Docket Number 50-346

Subject: Response to Questions Regarding the 2002 Steam Generator Tube Inspections  
(TAC No. MB9541)

RESPONSE TO REQUEST FOR ADDITIONAL INFORMATION  
DAVIS-BESSE NUCLEAR POWER STATION  
2002 STEAM GENERATOR INSPECTION (TAC NO. MB9541)

**Figure 1: Cumulative Distribution of Plus Point Voltages of Volumetric IGA Indications for the Past Three Outages at Davis-Besse**

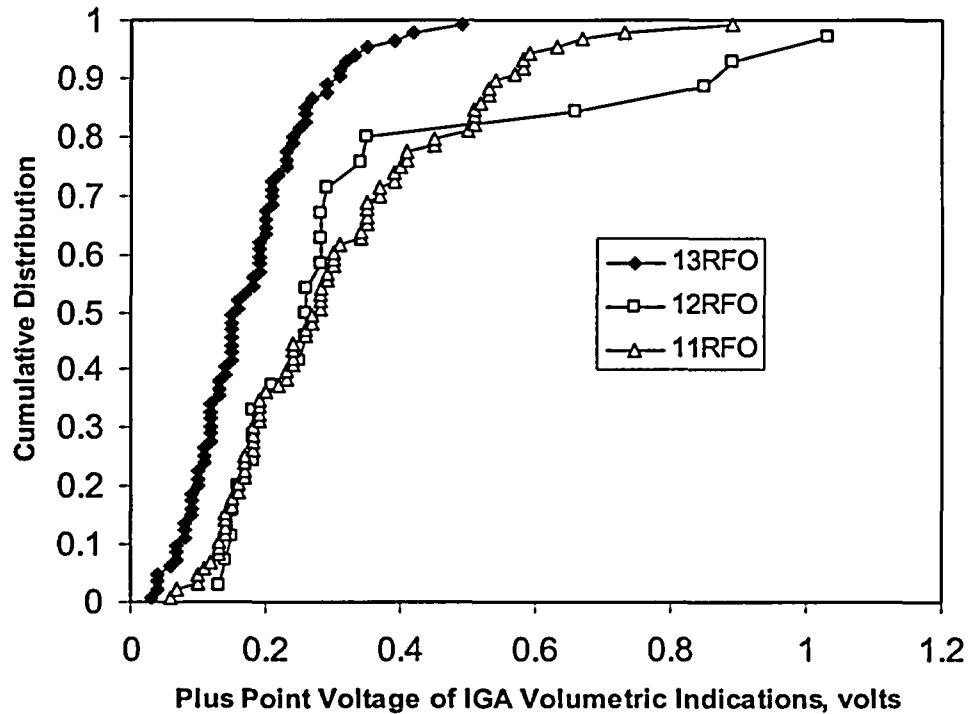
*A number of tubes with volumetric indications attributed to intergranular attack were plugged. Several of these indications were near 60 percent through-wall.*

*Discuss the growth rate for these indications and discuss whether an increase in growth rate has been occurring with time (if a growth rate can not be established, discuss whether the maximum and/or average depths observed during an outage has been increasing with time). If the growth rate (or maximum and average depths of the population of indications) has been increasing, discuss the implications to your tube integrity assessments.*

The end-of-cycle severity of volumetric indications exhibits an overall downward trend at the DBNPS. This is illustrated in Figure 1, which shows that the cumulative distribution of +Point voltages is shifting towards lower values; and in Figure 2, which shows that the average and upper 95th percentile voltages are lower for 13RFO than for the previous two inspections.
